# MDDP AMENDMENT & FINAL DRAINAGE REPORT

## MERIDIAN ROAD & BENT GRASS MEADOWS DRIVE

### GALLOWAY RESPONSE

#### Engineering Review

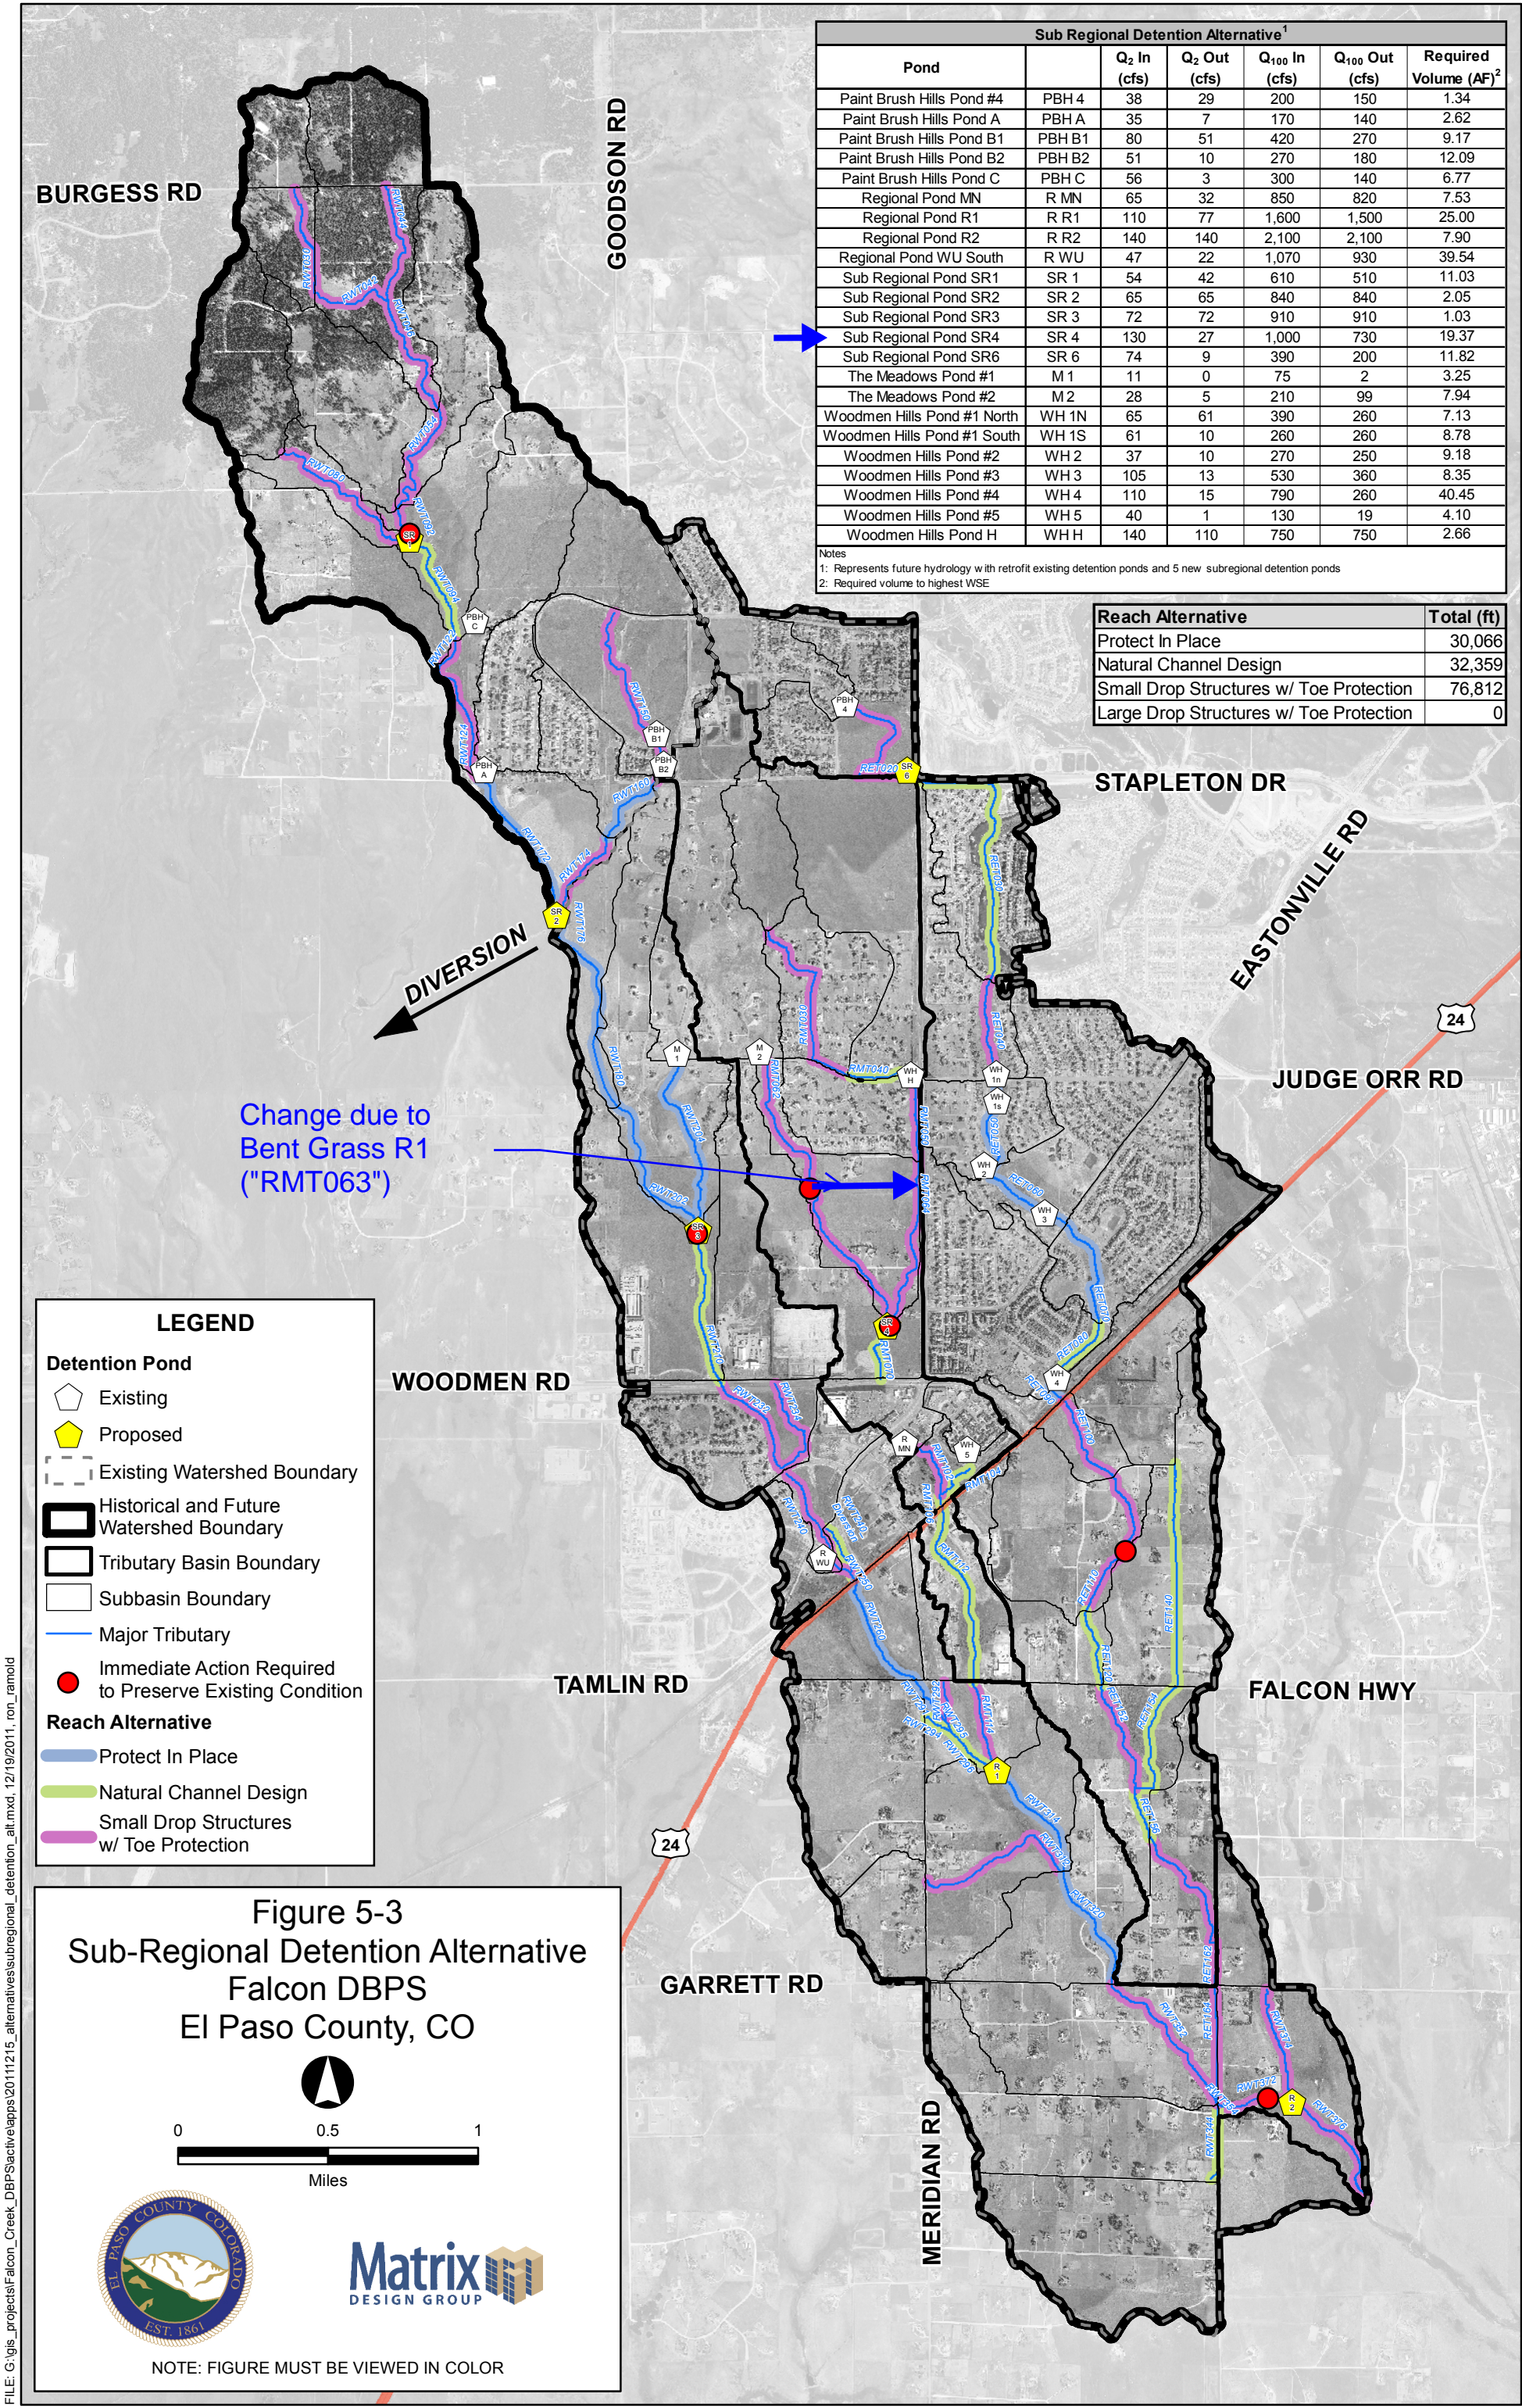
Replace Figure 3-13 (with prev. redlines) and add 3-12 if desired

**FUTURE MERIDIAN CHANNEL – PLAN**  
SCALE: 1"=50'

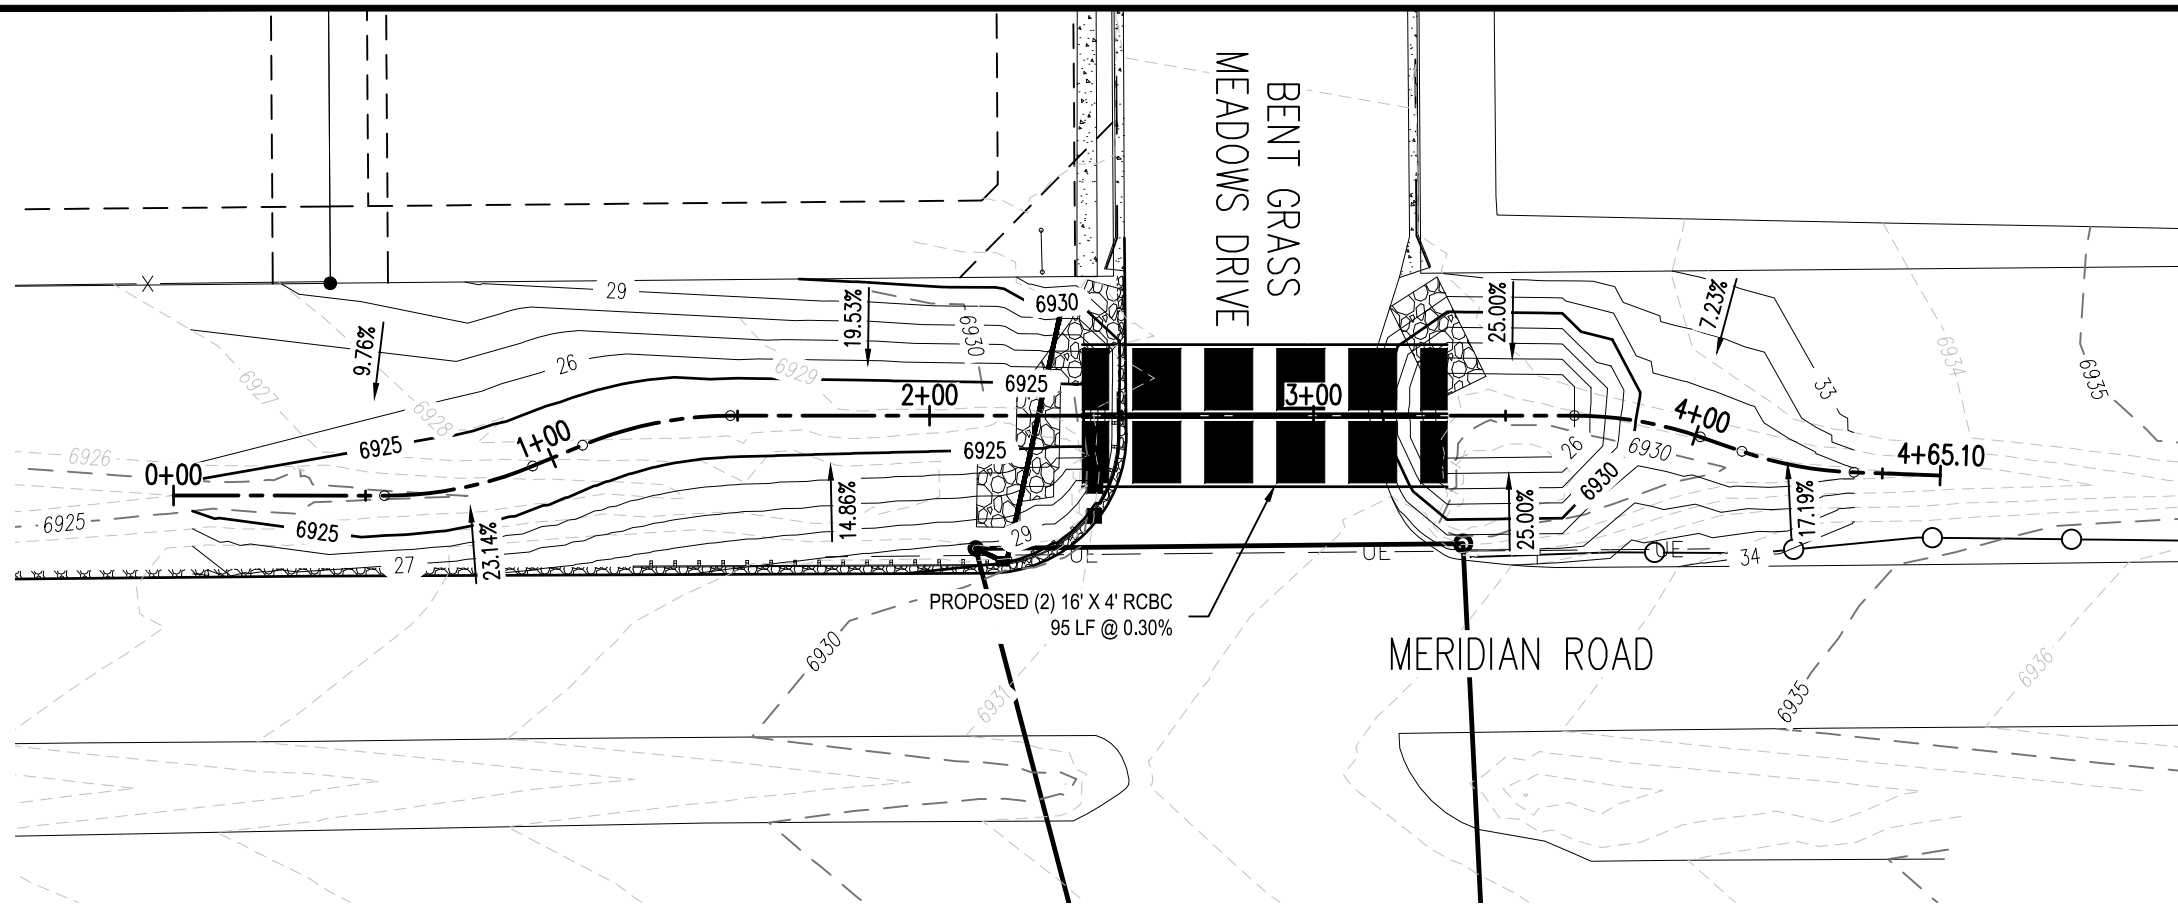
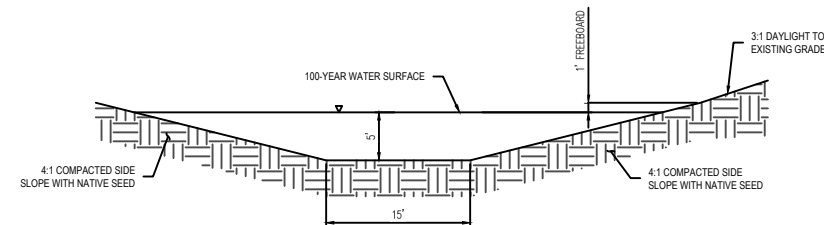
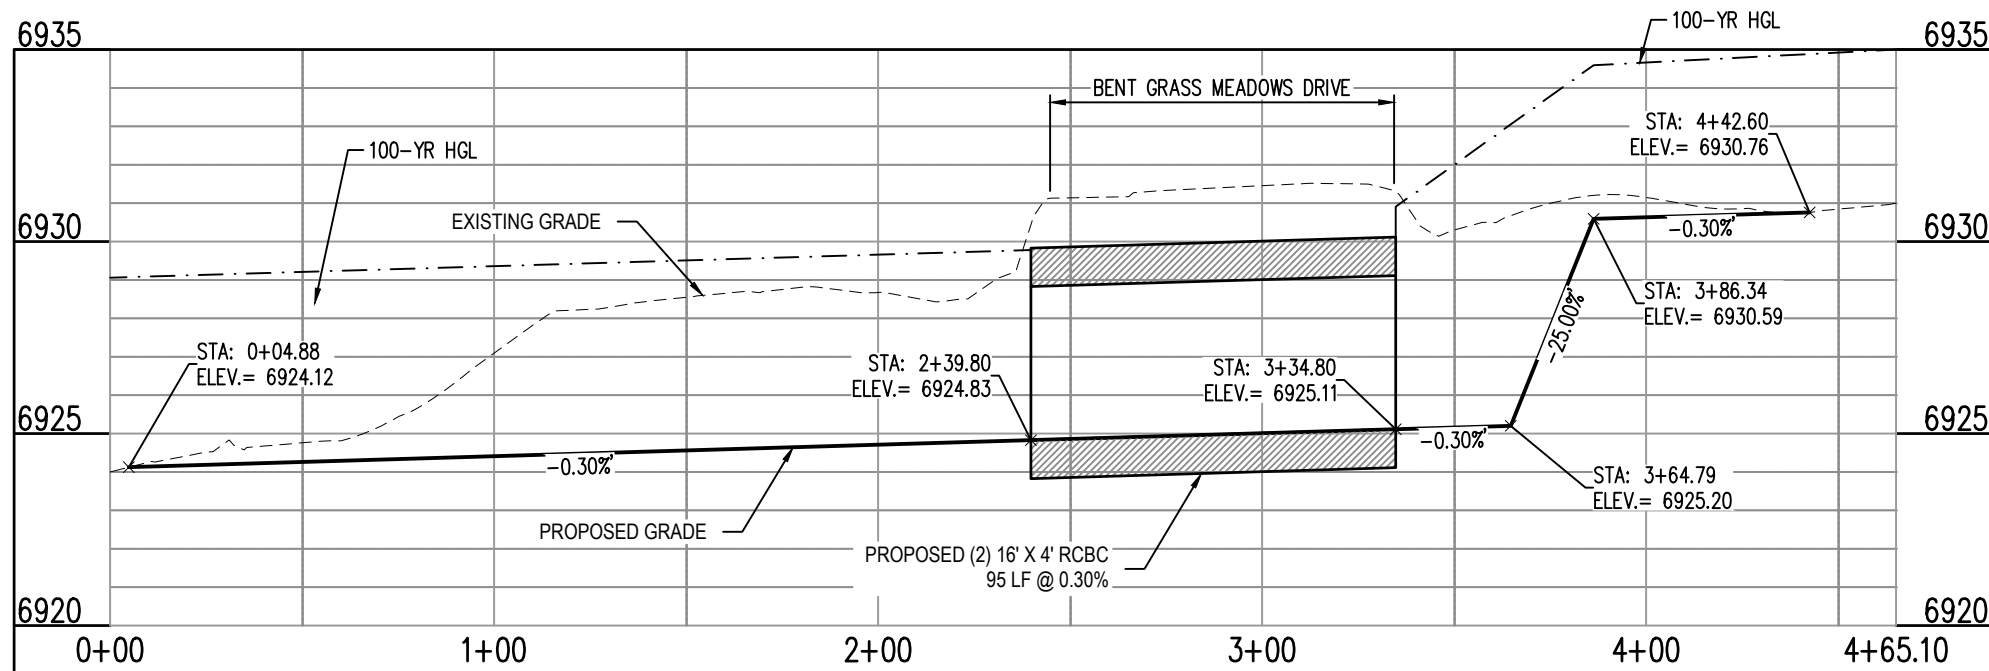
Add notations per the redlines below.

**Table 1 - Summary of Culvert Flows at Crossing: Add't Culverts for Add't Offsite Flow**

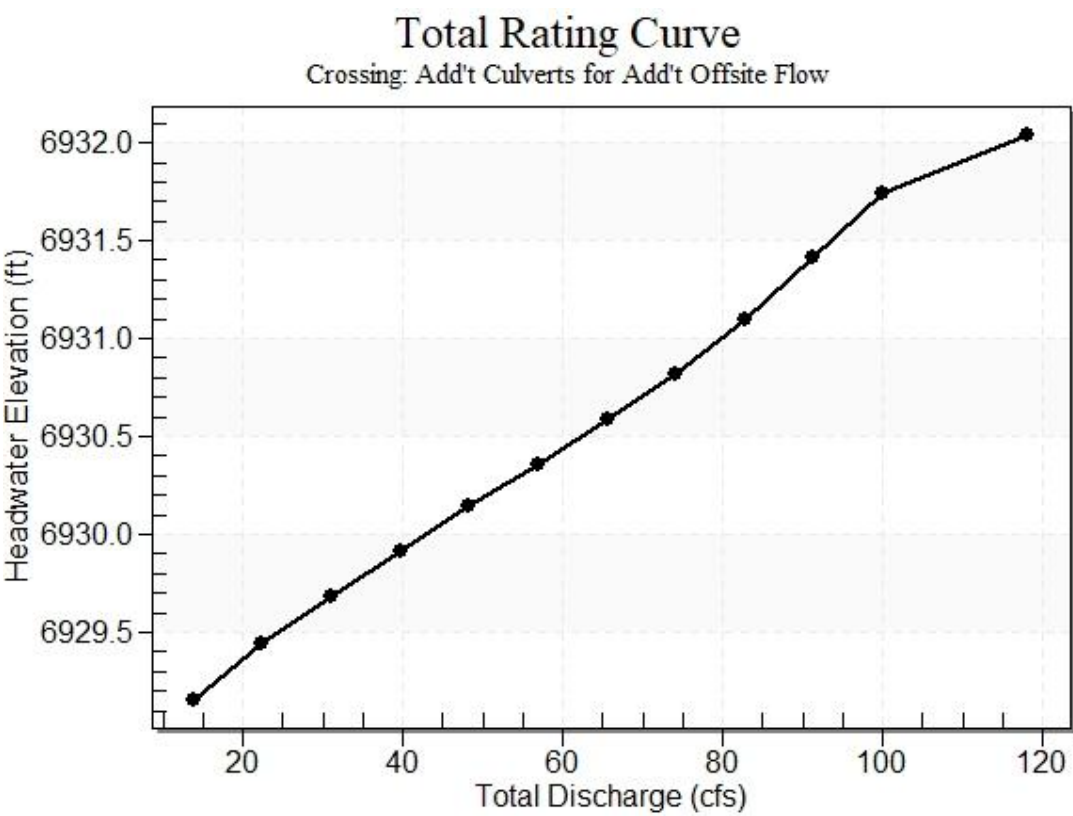
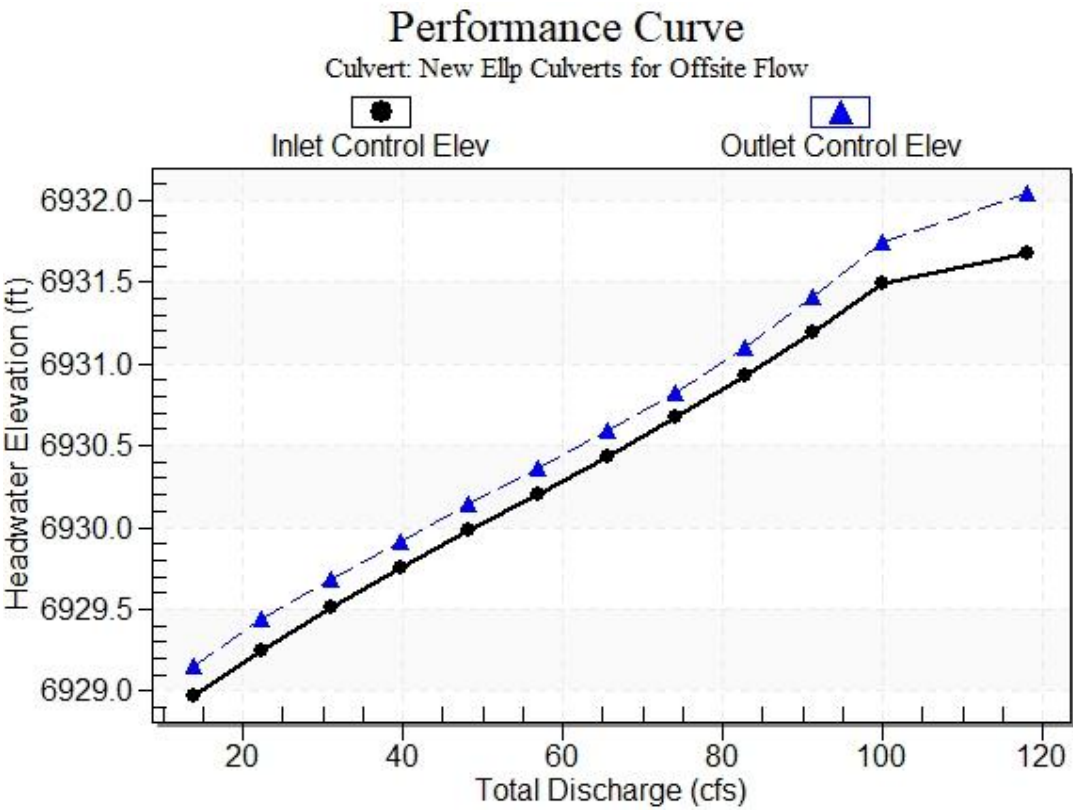
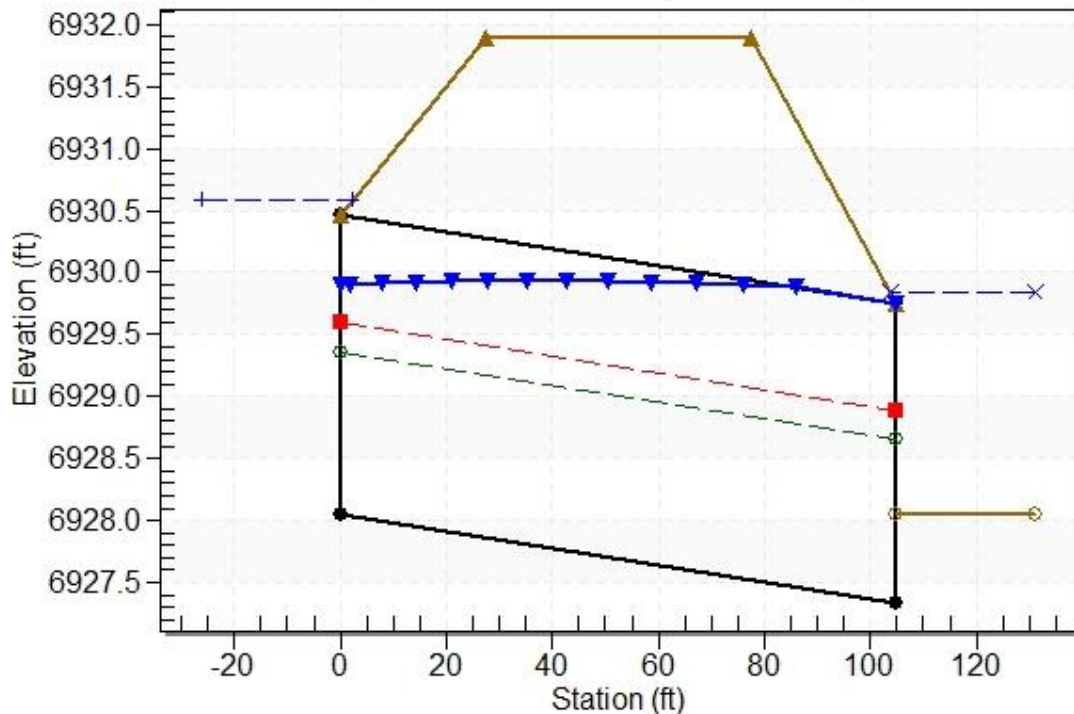
Verify based on  
hydrology  
comments
